**LHC**

REFERENCE <b>LHC-TCAP-EC-0001</b>
--------------------------------------

**ENGINEERING CHANGE REQUEST**

**Installation of New Passive Absorbers (TCAPM) for Warm Magnet Protection in IR7**

Figure 1 — Illustrative view of the present (top) and post-LS2 (bottom) layouts of the IR7 Q5 [2, 3]. The new TCAPM is represented by the brown box immediately upstream of the MQWA.D5, installed in the space freed by the removal of the MQWA.E5. A specular layout is planned for beam 2.

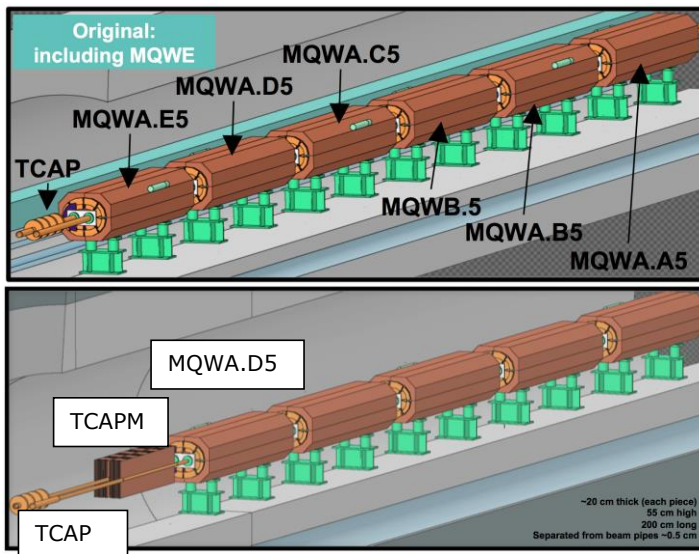
The requirements and a detailed performance assessment of possible new layouts were discussed in various Collimation Upgrade Specification meetings (see the presentations by C. Bahamonde in [2, 3, 4, 5, 6]). Figure 1 shows an illustrative sketch, taken from the FLUKA geometry used in simulations, the present layout (top view) and the modified one (bottom view) [2,3]. The latest design was reviewed and endorsed in the 107<sup>th</sup> ColUSM [7].

The present passive collimator TCAP (installed upstream of the present MQWA.E5, see Figure 1) will remain in place and the new passive absorber TCAPM will be added. The latter is outside the vacuum, contrary to the existing passive absorbers. The same elliptical chambers as the present MQW one will be used in this area.

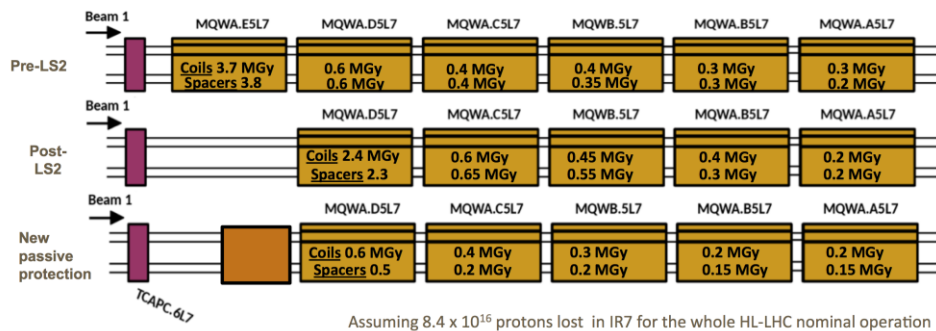
The computed doses in all modules of the Q5 magnets for beam 1, estimated for the whole lifetime of the HL-LHC project [8], are illustrated in Figure 2 for three different layouts [2, 3]:

Dose values are estimated both for the coil and for the spacers [1]. Note that for all cases, the present TCAP (TCAPC.6L7.B1) collimator remains at the same location, as this was found to produce good performance. This also avoids intervening on a radioactive collimator. It is clear that without an improvement of the passive collimation layout (middle plot), doses on the downstream MQWs would be much higher than in the present layout. In particular, the dose on the coil spacers [1] of the most exposed magnet would be about a factor 4 larger. The proposed solution with TCAPM (bottom line) described in detail in the next section, solves this issue and brings the doses to an acceptable level.

Figure 3 — Overall design of the TCAPM. Lengths are given in mm. Courtesy of L. Gentini [9].

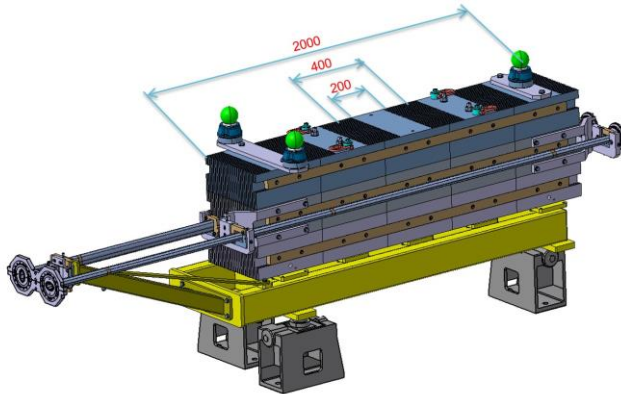
The new absorber's design [8] is shown in Figure 3. More details can be found in the mechanical layout drawings of the long straight section for high luminosity (LSXH\_0014 for LSSR7 and LSXH\_0013 for LSSL7) [~~1010~~, ~~1111~~] and in [12]. The SmarTeam references are

Figure 4 — The three assembly blocks of the TCAPM. Courtesy of L. Gentini [9].

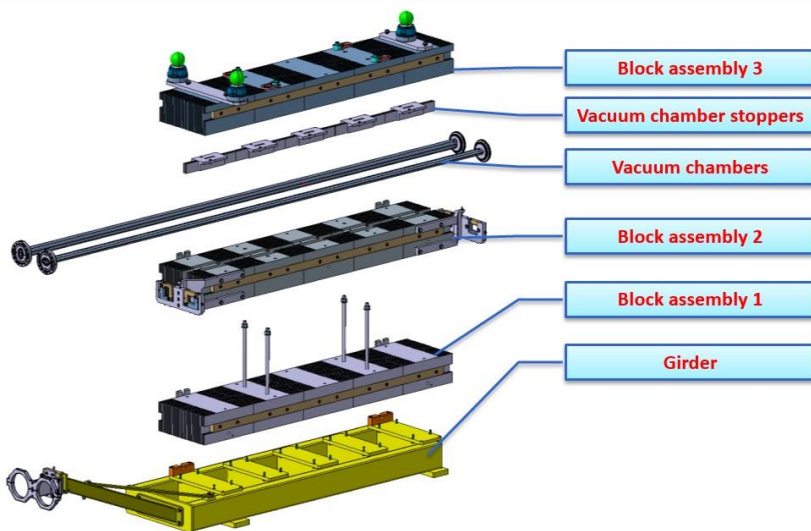
A new support that will be installed under the vacuum chamber will house a modular structure made of steel blocks, assembled together to fill a volume that ensures adequate shielding of the downstream magnet. The supporting structure consists thereby of a girder (see Figure 4) resting on the reused magnet support feet provided by TES- MSC. The absorbing part consists of three block assemblies shown in Figure 4. The assemblies 1, 2 and 3 weight respectively 781 Kg, 756 Kg and 779 Kg, for a total of about 2590 Kg with the support. The TCAPM transverse cross section is shown in [Figure 5](#). The absorber assemblies are mounted around the existing elliptical beam pipes in a way that leaves minimum empty spaces. The integration layout is shown in [Figure 6](#). The longitudinal central positions of the new passive absorbers are 19852.4064 m for Beam 1 and 20135.9184 m for Beam 2.
